52-001
ABWR

Subject ABWR ITAAC

2.10 Power Cycle

Figure 2.10.1 Turbine Main Steam System

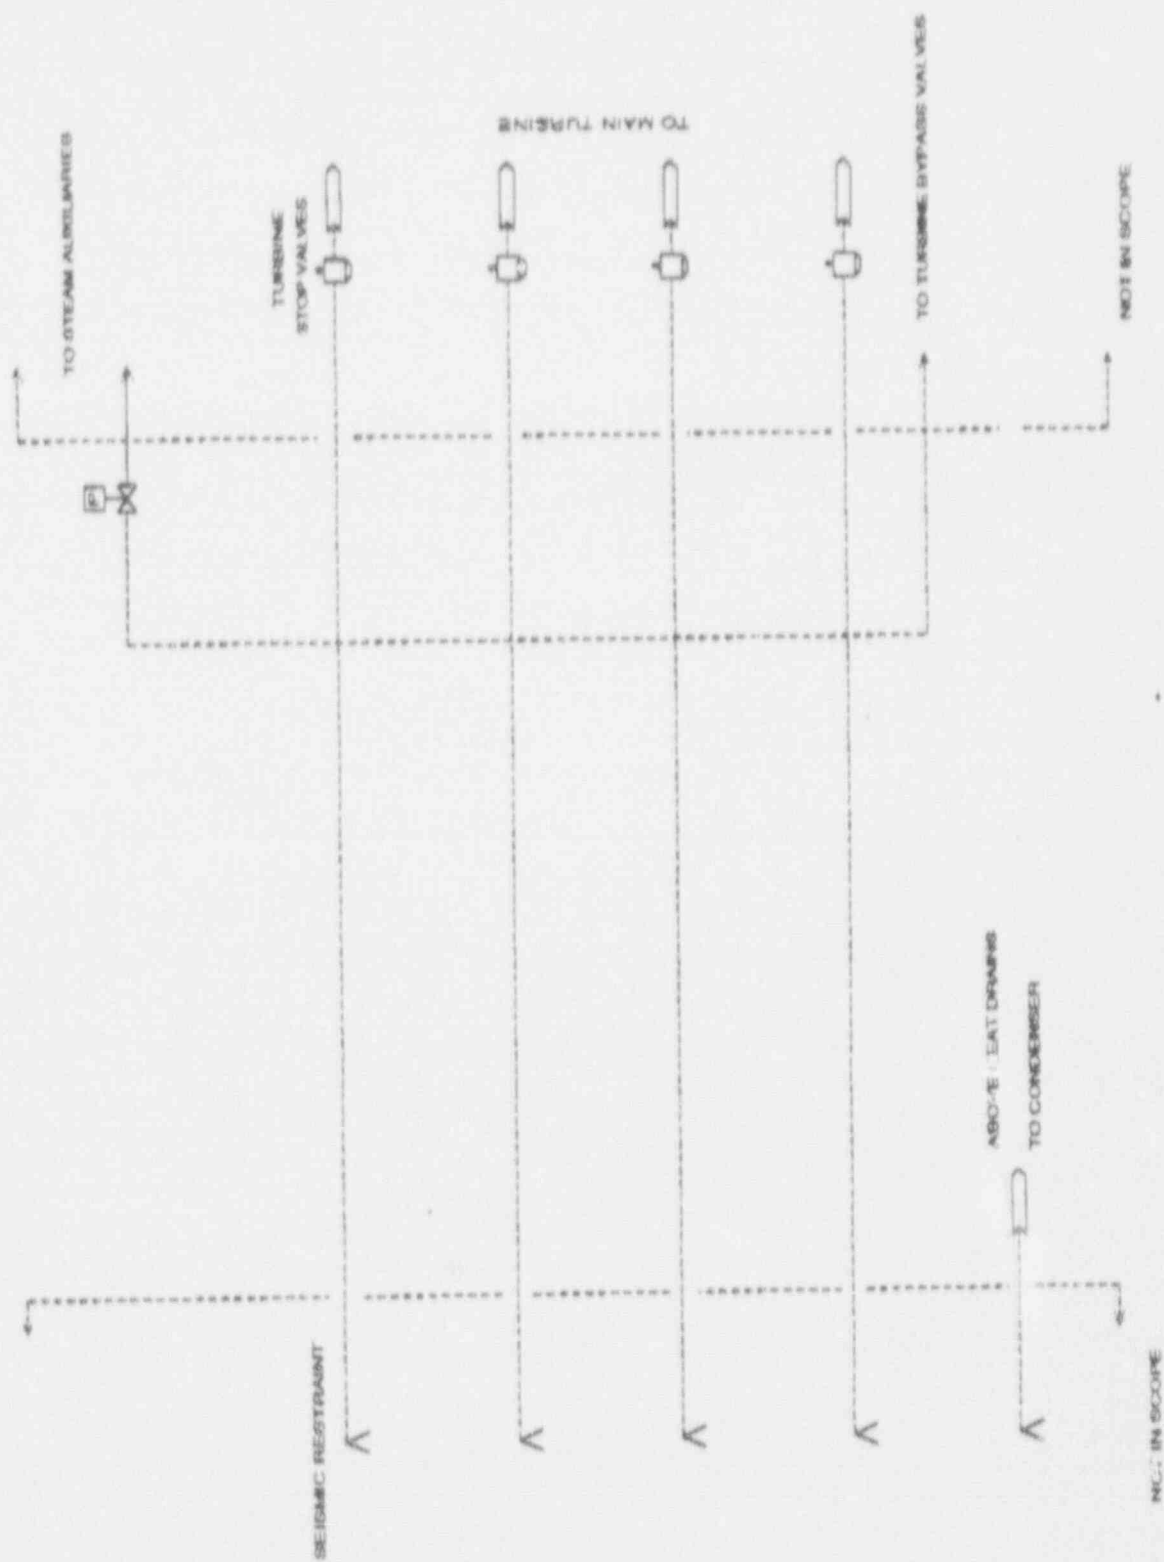
The Main Steam (MS) System (Figure 2.10.1) supplies steam generated in the reactor to the turbine. This Tier 1 entry addresses that portion of the MS System that ranges between, ~~but does not include, the outermost containment isolation valves and the turbine stop valves, but does not include, the seismic restraint downstream or the outermost containment isolation valves and the turbine stop valves.~~

The MS System main steam piping consists of four lines from the ~~seismic restraint outboard main steamline isolation valves~~ to the main turbine stop valves. The header arrangement upstream of the turbine stop valves allows them to be tested on-line with minimum load reduction and also supplies steam to the power cycle auxiliaries, as required.

Figure 2.10.2a Condensate and Feedwater System

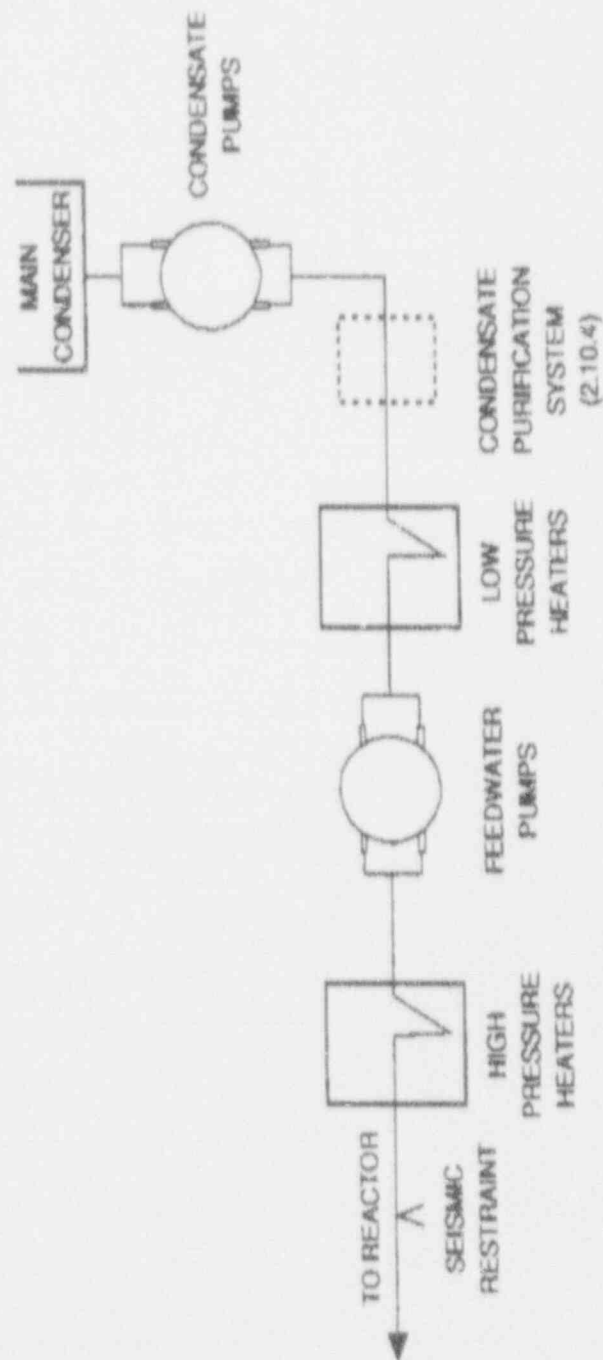
The function of the Condensate and Feedwater (CF) (Figure 2.10.2a) System is to receive condensate from the condenser hotwells, supply condensate to the cleanup system, and deliver high-purity feedwater to the reactor, ~~at the required flow rate, pressure and temperature.~~ Condensate is pumped from the main condenser hotwell by the condensate pumps, passes through the feedwater heaters to the feedwater pumps, and then is pumped through the high pressure heaters to the nuclear Steam Supply System.

The CF System boundaries ~~considered here~~ extend from the main condenser outlet to (but not including) the ~~second isolation valve seismic restraint~~ outside the containment ~~and downstream of the outermost isolation valve.~~ The CF System consists of the piping, valves, heat exchangers, controls and instrumentation, and the associated equipment and subsystems which supply the reactor with heated feedwater in a closed steam cycle utilizing regenerative feedwater heating.

Figure 2.10.2b Main Condenser Evacuation System

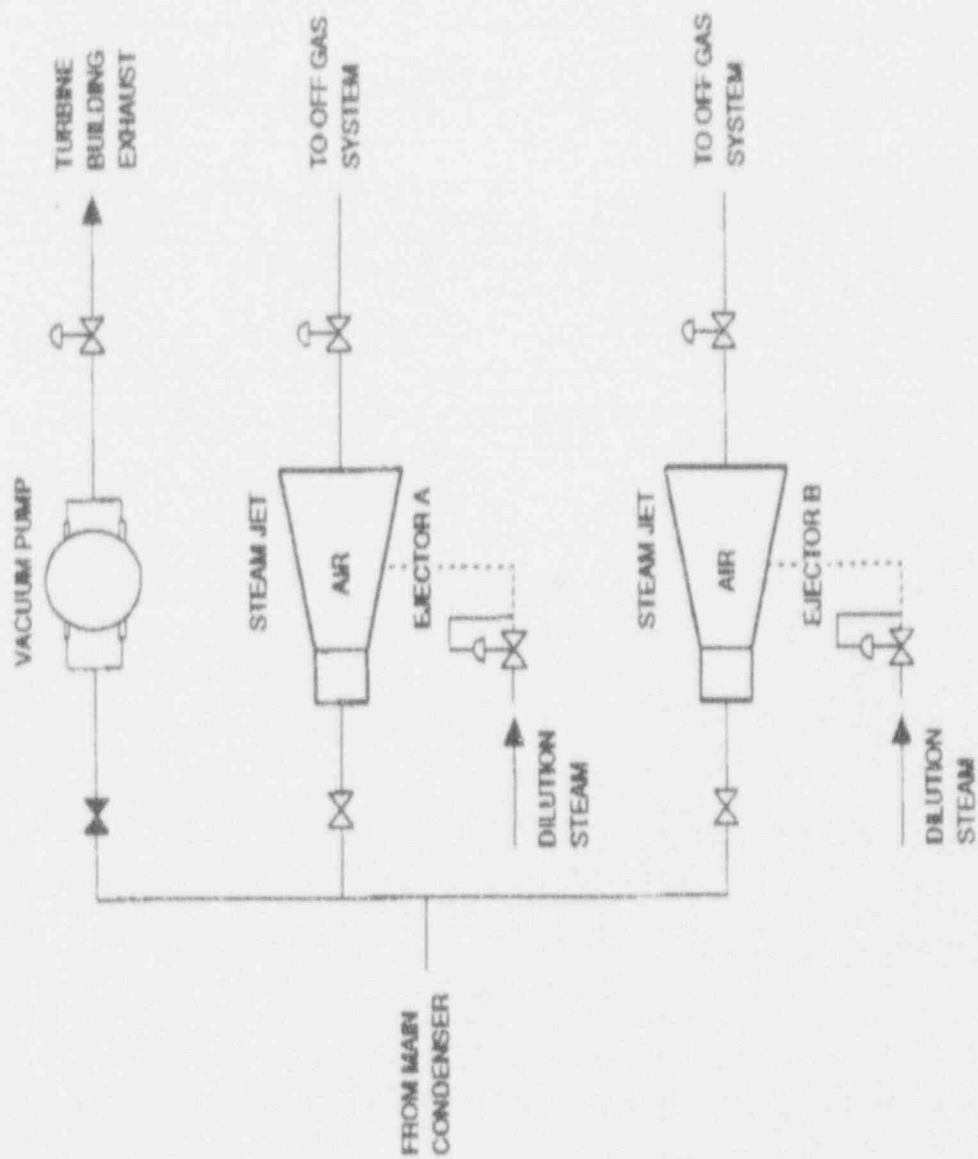
~~Noncondensable gases are removed from the power cycle by~~ The Main Condenser Evacuation (MCE) System (Figure 2.10.2b). ~~The MCE System~~ removes the hydrogen and oxygen produced by the radiolysis of water in the reactor, and other power cycle noncondensable gases, and exhausts them to the offgas system during plant power operation, and to the turbine building compartment exhaust system at the beginning of each startup.

The MCE System consists of ~~two 100% capacity, double stage, of redundant~~ steam jet air ejectors (SJAE) units ~~(complete with intercondensers)~~ for power plant operation, and a mechanical vacuum pump for use during startup. ~~The last stage of the SJAE unit is normally in operation and the other is on standby.~~

Steam supply to the ~~second stage ejector~~ SJAE is maintained at a minimum specified flow rate to ensure adequate dilution of the hydrogen and prevent the offgas from reaching the flammable limit of hydrogen.

Figure 2.10.23 Circulating Water System

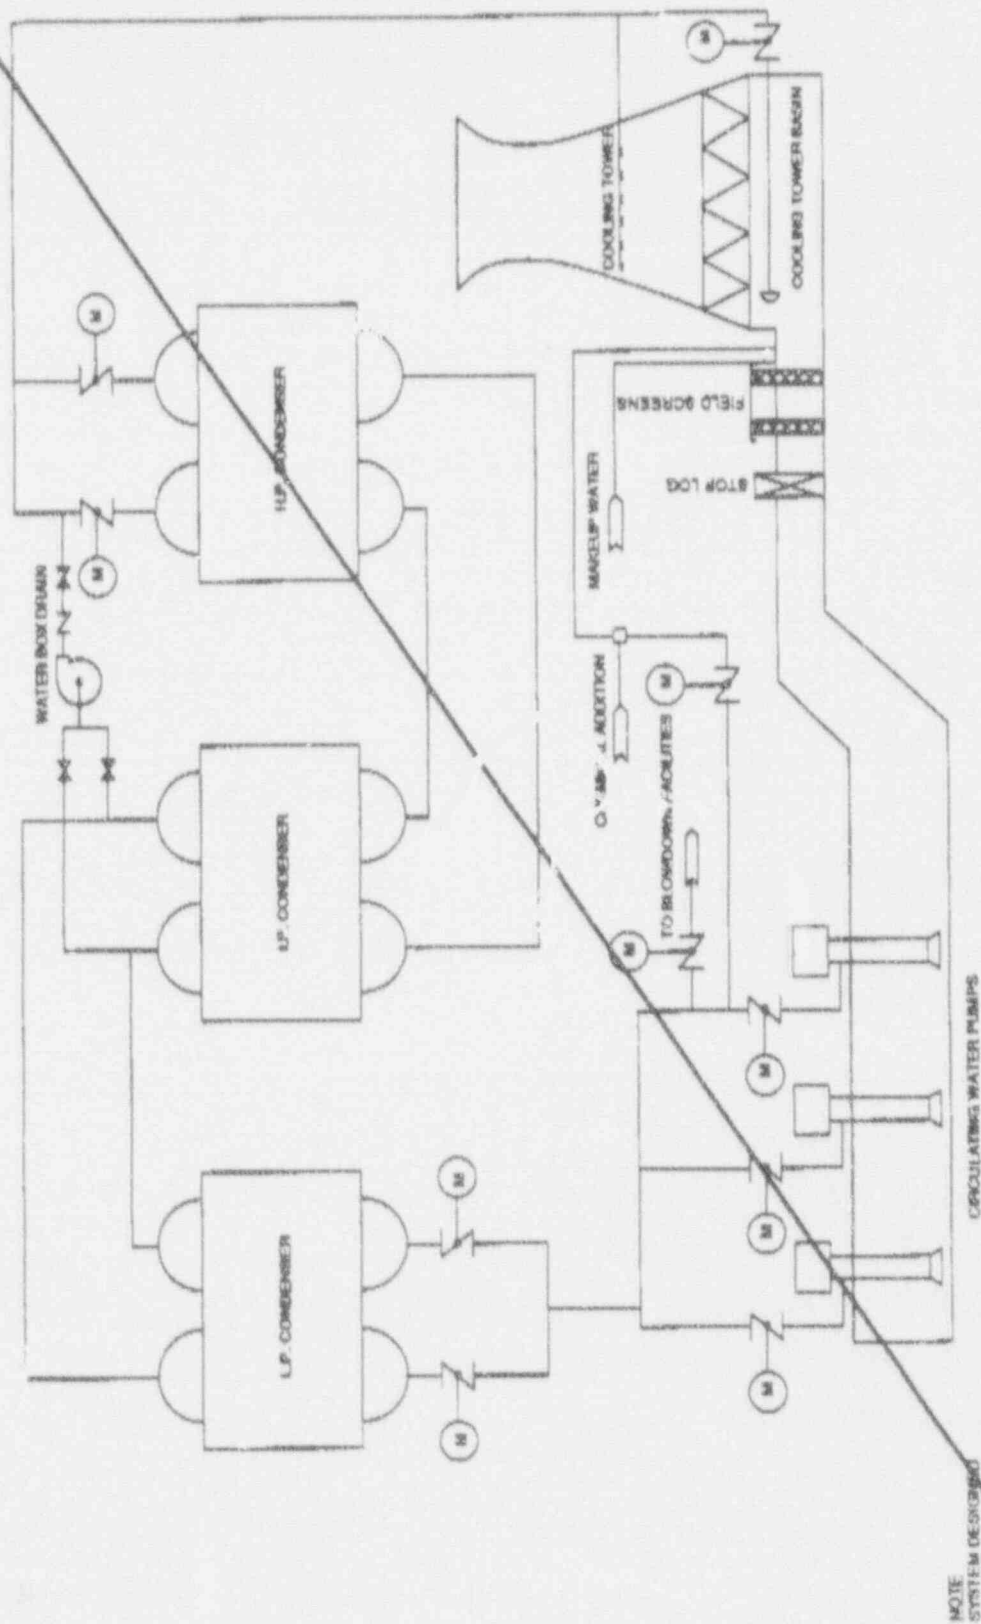
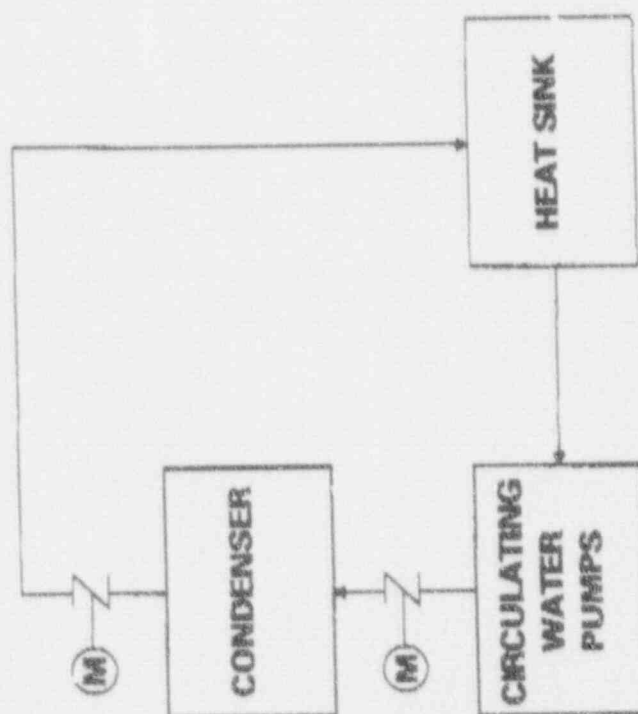
REVISED, SEE NEW FIG. 2.10.23
